U.S. Department
of Transportation
**Federal Highway
Administration**

January 8, 2008

In Reply Refer To: HSSD/B-137C

Thank you for your letter of October 19, 2007, requesting a modification to the anchorage of your company's 4-cable barrier. Your original test level 4 (TL-4) Gibraltar cable barrier was formally accepted for use on the National Highway System (NHS) in the September 9, 2005, Federal Highway Administration (FHWA) acceptance letter B-137A. The tested design, as described in that letter, consisted of cables placed 20 inches, 30 inches, and 39 inches above the ground line.

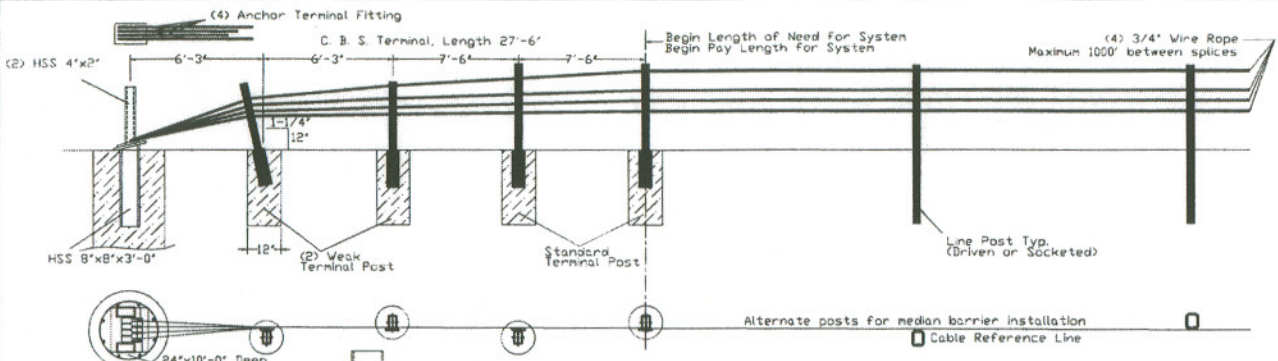
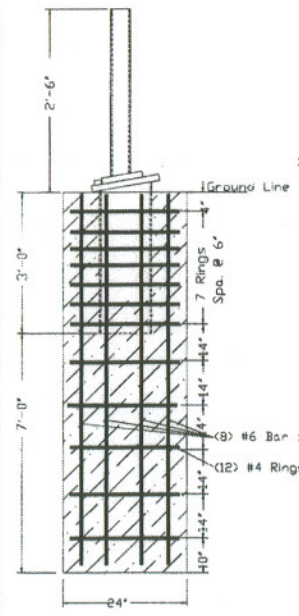
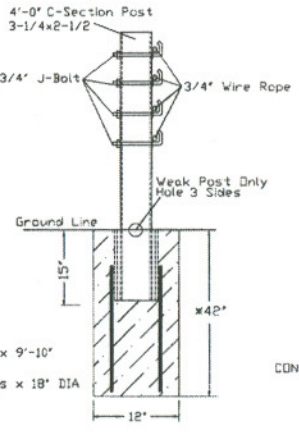
In our October 27, 2006, letter B-137A1 we accepted your 4-cable design having the lower three cables at the same heights as your TL-3 design while retaining the top cable at the tested TL-4 height of 39 inches. The addition of the fourth cable required a modified "hairpin" and lock plate to retain the cables at the proper heights. In order to "anchor" the added cable you tapered that 25-inch high cable down to the bottom (20-inch) cable between the first line post and the last terminal post and connected the two cables with a series of four cable clamps. Because of concerns raised over this splicing treatment, especially on downstream terminals, you have proposed to anchor each of the four cables separately.

The modified anchor is shown on the enclosed drawings for reference and features the fourth cable attached directly to the anchor post foundation plate instead of being cable clamped to the bottom cable. You also added a fourth J-bolt to each terminal post to accommodate the fourth cable. We concur in this modification and find it acceptable for use with your four-cable barrier.
